**Town of Surfside
DESIGN REVIEW BOARD/
PLANNING & ZONING BOARD
AGENDA**

August 30, 2018 – 6:00 p.m.

Subject: 8995 Collins Avenue
From: Guillermo Olmedillo, Town Manager
 Sarah Sinatra Gould, AICP, Town Planner

Comments Based on Plan Submittal: 2nd submittal (revised plan)

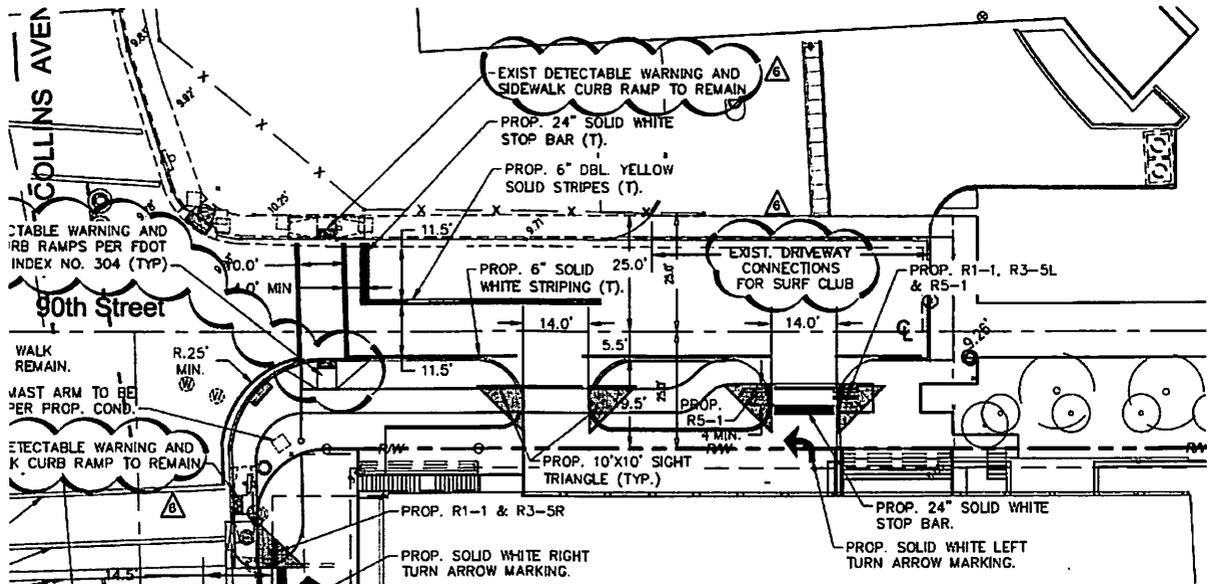
1. Projects that have direct or immediate access or is within one-half block of Collins Avenue, Harding Avenue or 96th Street shall be subject to the review and approval by FDOT for compliance with FDOT standards. Please provide an approval letter from FDOT as part of your resubmittal. (Town of Surfside Code Section 90-81.11)

Tom Hall 04/23/18 Response: The Permits Section of the Florida Department of Transportation's District VI office does not provide "Pre-App" letters in the manner of District IV. Therefore, it is not possible to provide the requested letter until the time that a Driveway Permit is applied for. As soon as the Driveway Permit is obtained, a copy will be provided to the Town.

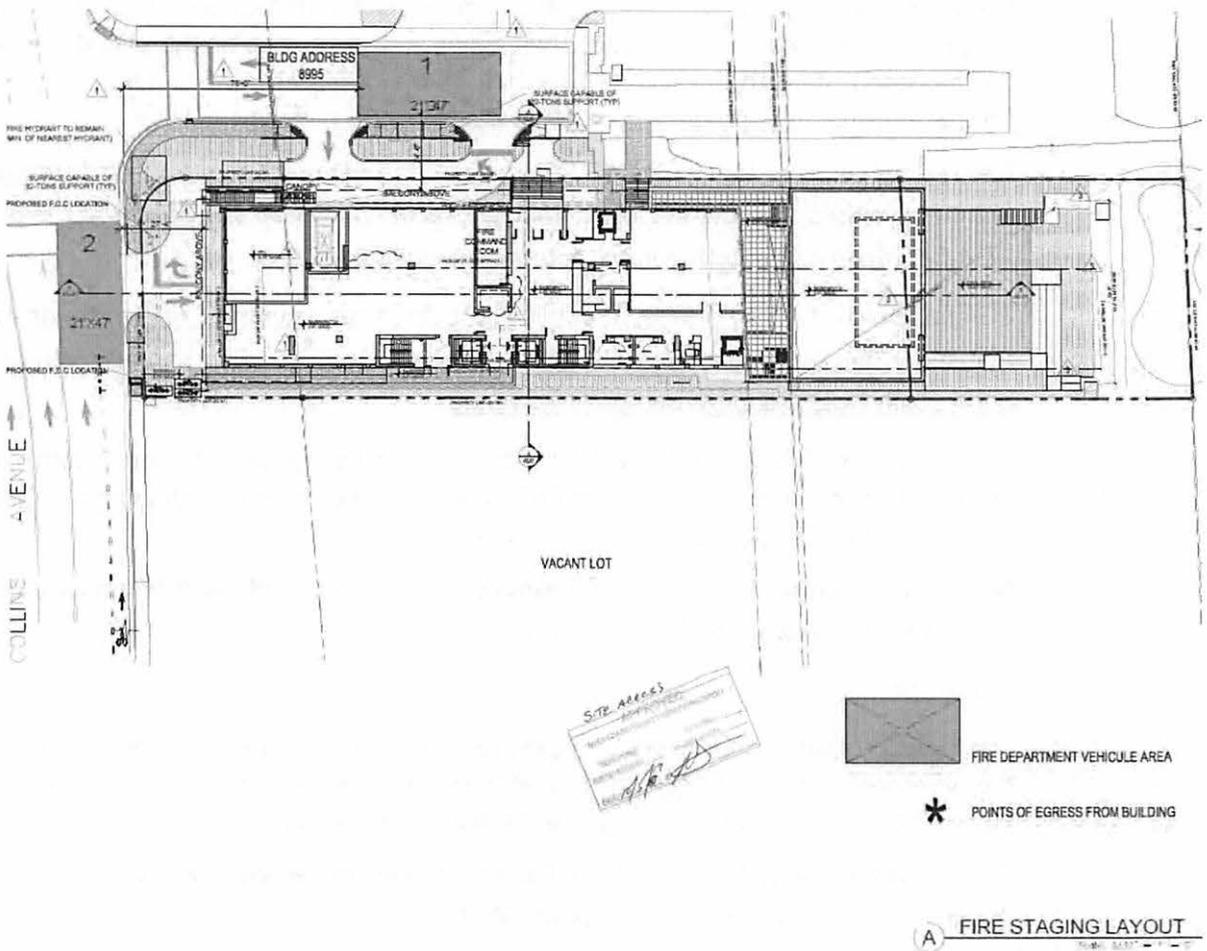
- Please either label the directional arrows that are shown on the pavement marking and signage plan as "informational only" or remove the symbols from the plans. It is unclear from the design plans if these are to be installed as part of the project.

Ocean Engineering, Inc. 04/23/18 Response: *the directional arrows have been removed from the pavement marking and signage plan. (WL)*

Figure 2 – P.M. Peak Hour Traffic Counts
8995 Collins Avenue
Town of Surfside, Florida

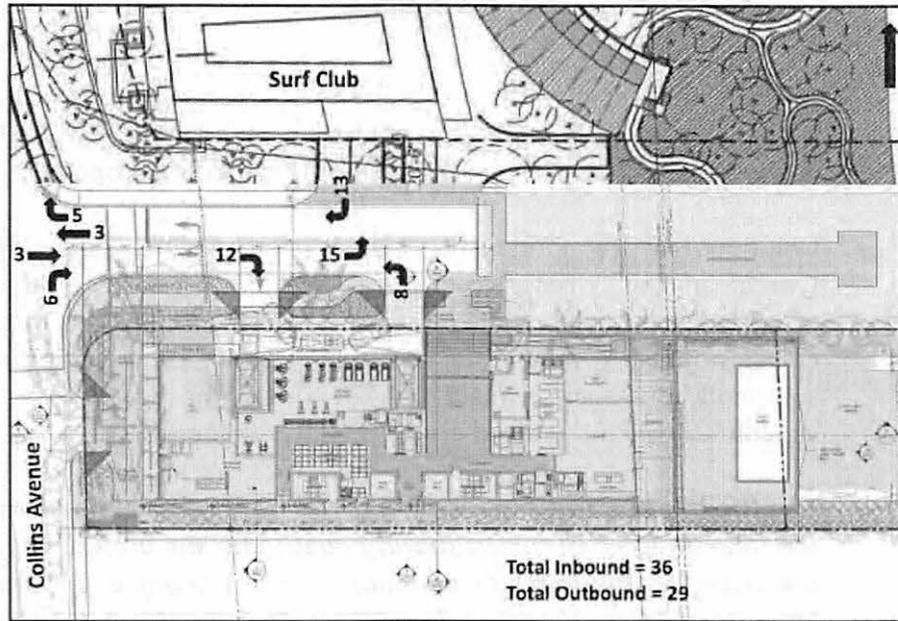
As the reviewer can see by perusing the enclosed four-run-average Simtraffic queue report, the maximum queue, which is the total queue, not a percentage of the queue, is 49 feet in length. Simtraffic considers one vehicle length to be 19.5 feet in its queuing analysis so the average maximum queue observed in the four runs, 49 feet, is equivalent to 2.51 vehicles, or for practical purposes, three vehicles.

CGA response: Addressed. The applicant provided a new 8995 Collins Valet Parking Operational Plan which depicts the staged valet operation. It should be noted that there is limited space for eastbound left turning vehicles into the Surf Club development to queue on 90th Street. The Simtraffic queue report identifies an EBL queue of 54 LF (around 3 vehicles). The post development valet operational analysis study will need to evaluate not only the valet operations at 8995 Collins but also the traffic operations within 90th Street including the driveway operations at the Surf Club and 90th Street.

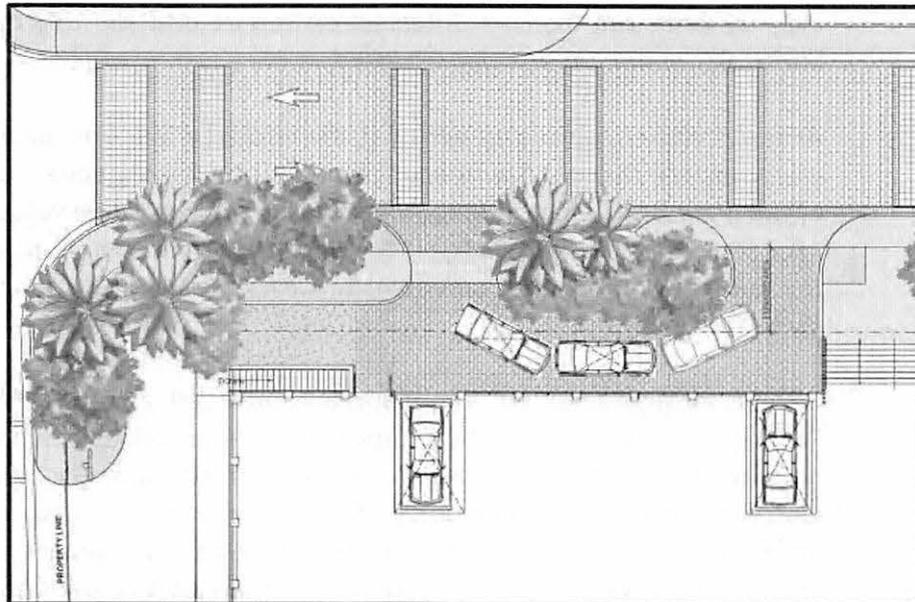
As the reviewer can see by perusing the enclosed four-run-average Simtraffic queue report, the maximum queue, which is the total queue, not a percentage of the queue, is 49 feet in length. Simtraffic considers one vehicle length to be 19.5 feet in its queuing analysis so the average maximum queue observed in the four runs, 49 feet, is equivalent to 2.51 vehicles, or for practical purposes, three vehicles.

CGA response: Addressed. The applicant provided a new 8995 Collins Valet Parking Operational Plan which depicts the staged valet operation. It should be noted that there is limited space for eastbound left turning vehicles into the Surf Club development to queue on 90th Street. The Simtraffic queue report identifies an EBL queue of 54 LF (around 3 vehicles). The post development valet operational analysis study will need to evaluate not only the valet operations at 8995 Collins but also the traffic operations within 90th Street including the driveway operations at the Surf Club and 90th Street.

CONFLICT POINTS DIAGRAM

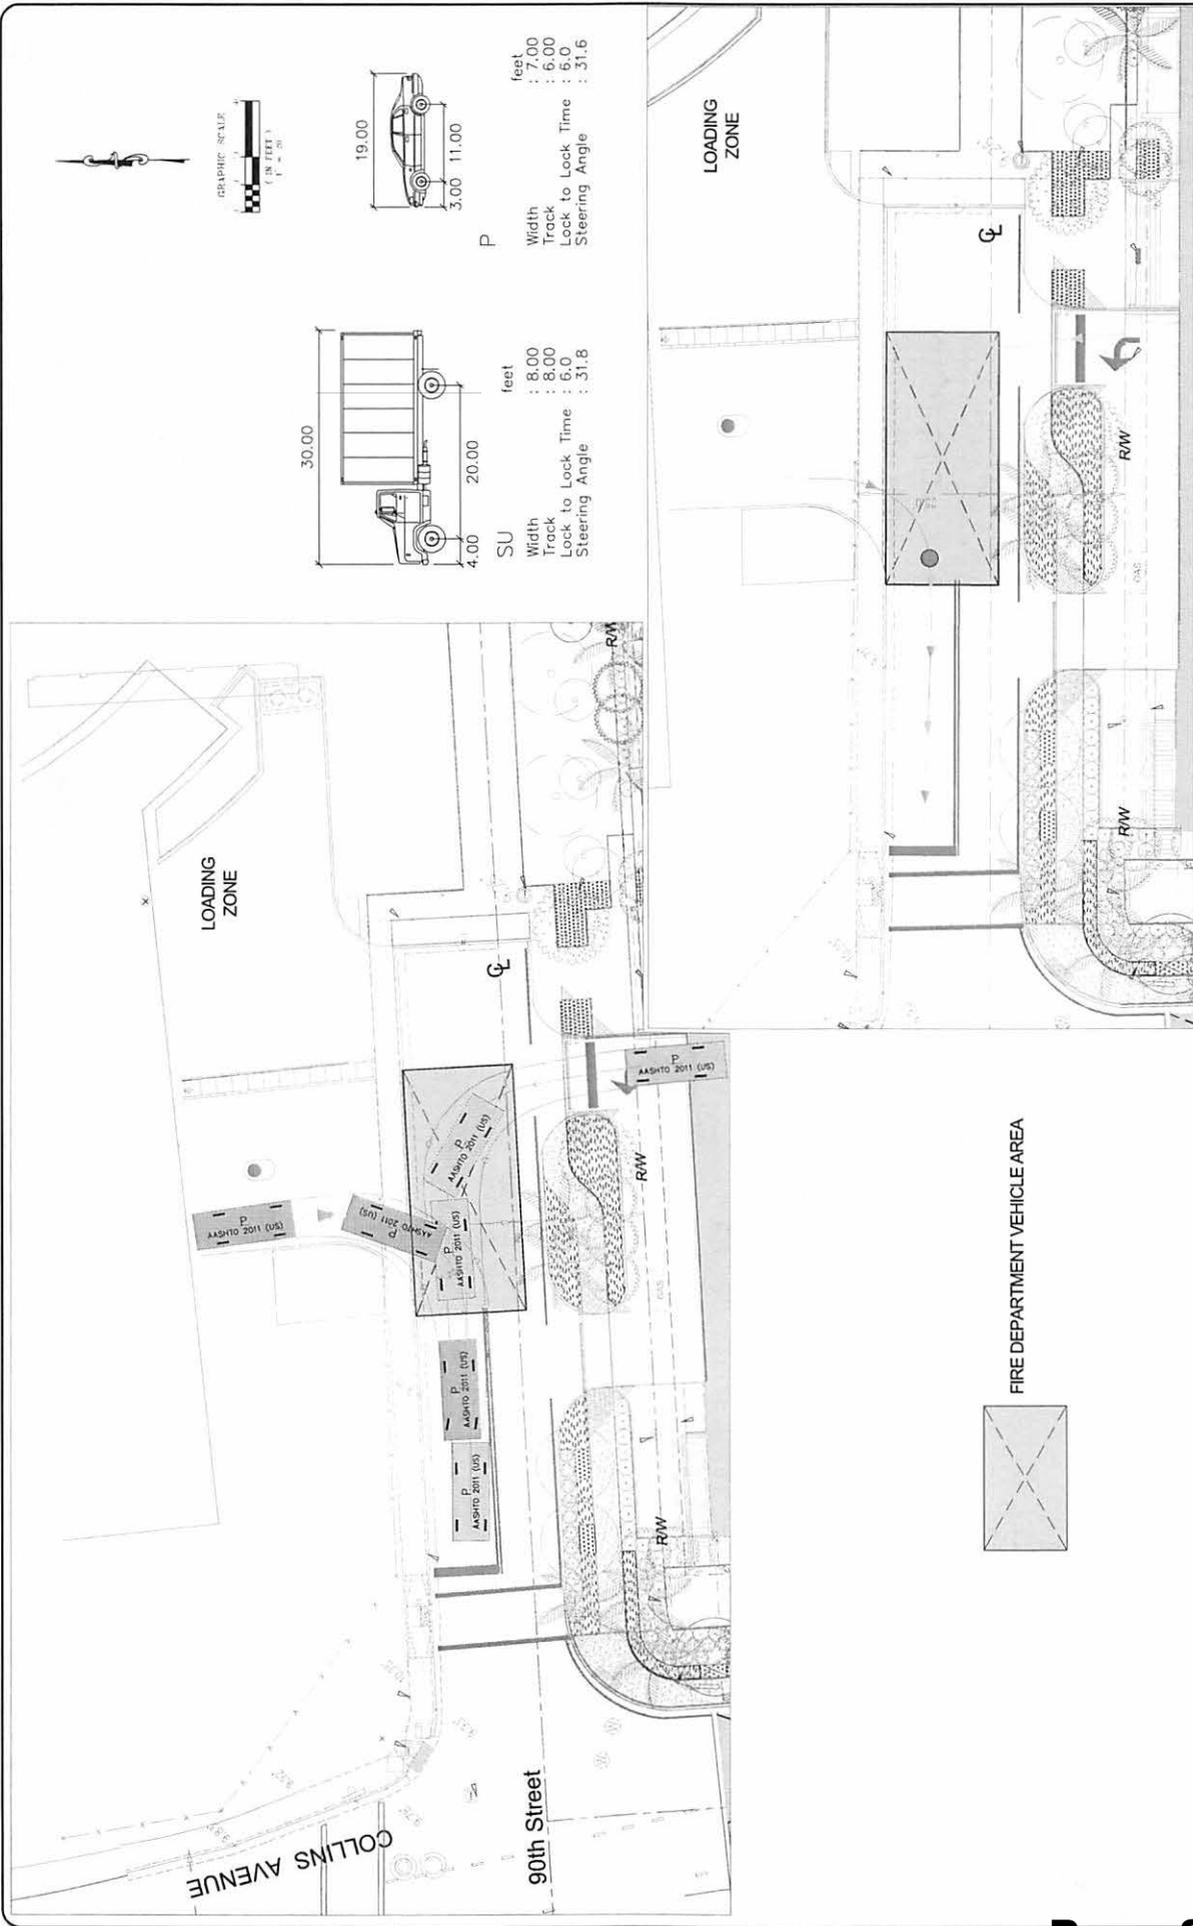
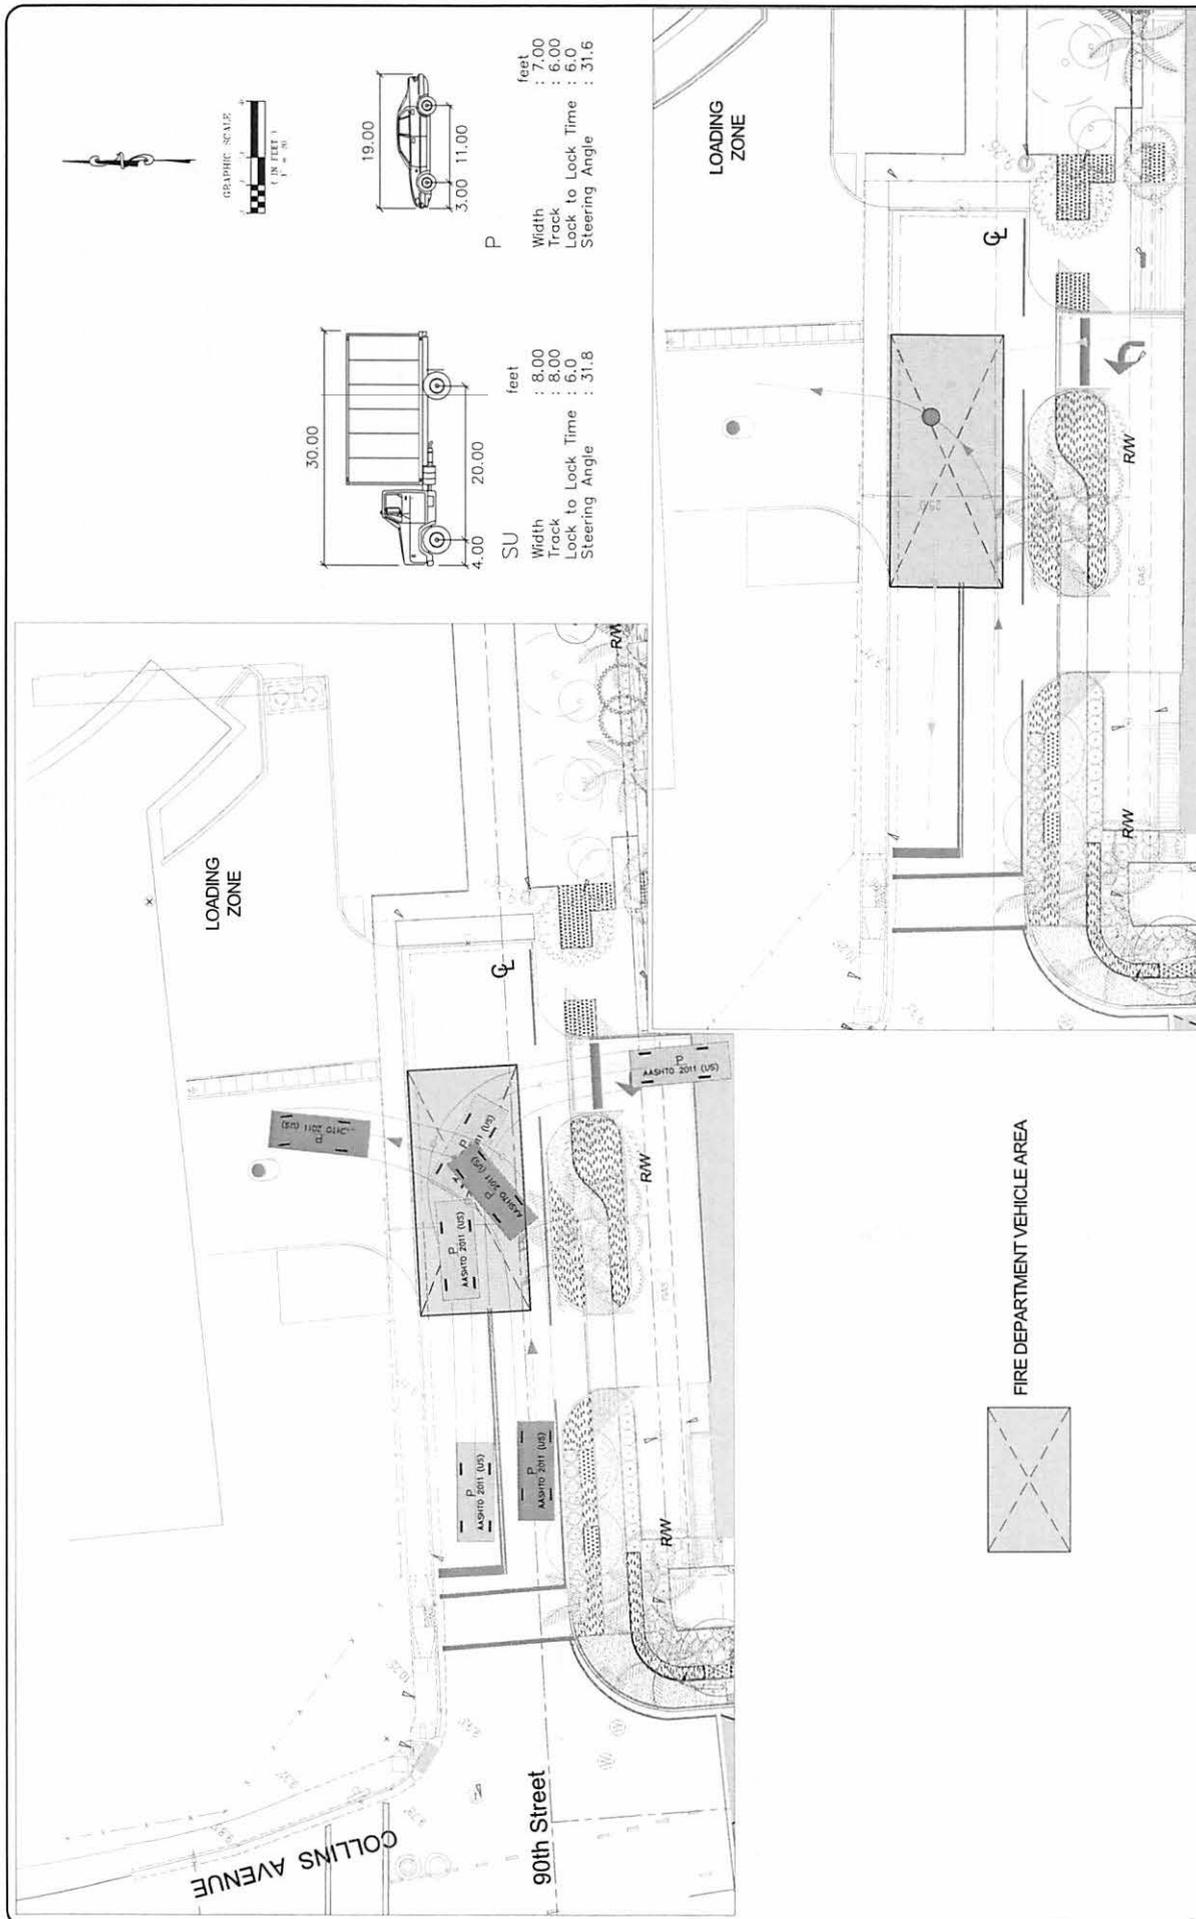
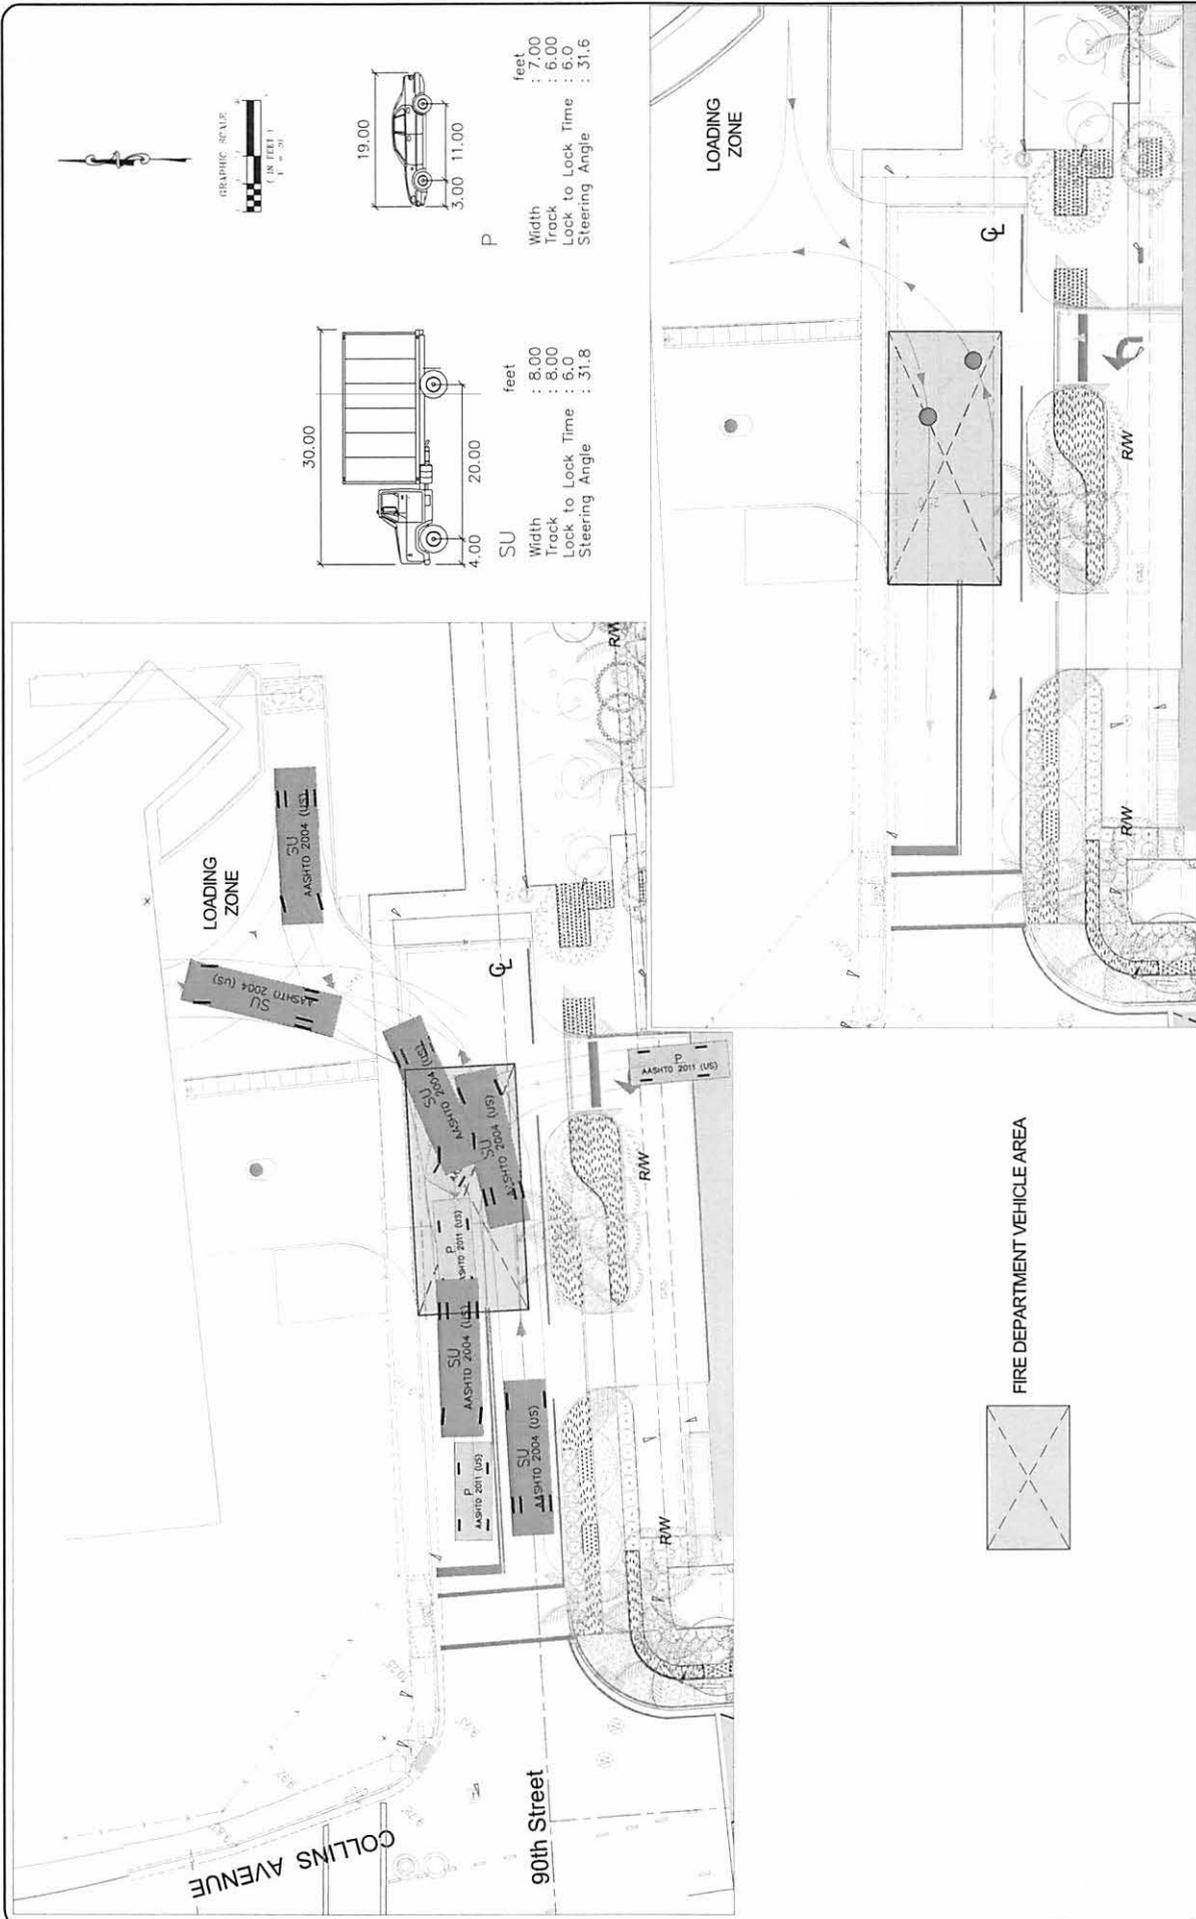
To demonstrate the concerns, staff prepared the attached Conflict Point Drawing which shows the number of conflicts that could potentially occur within the 90th Street public right of way. Subsets of the overall Conflict Point Drawing were created that show all of the individual movements. This graphic also includes the Fire Rescue laddering area.
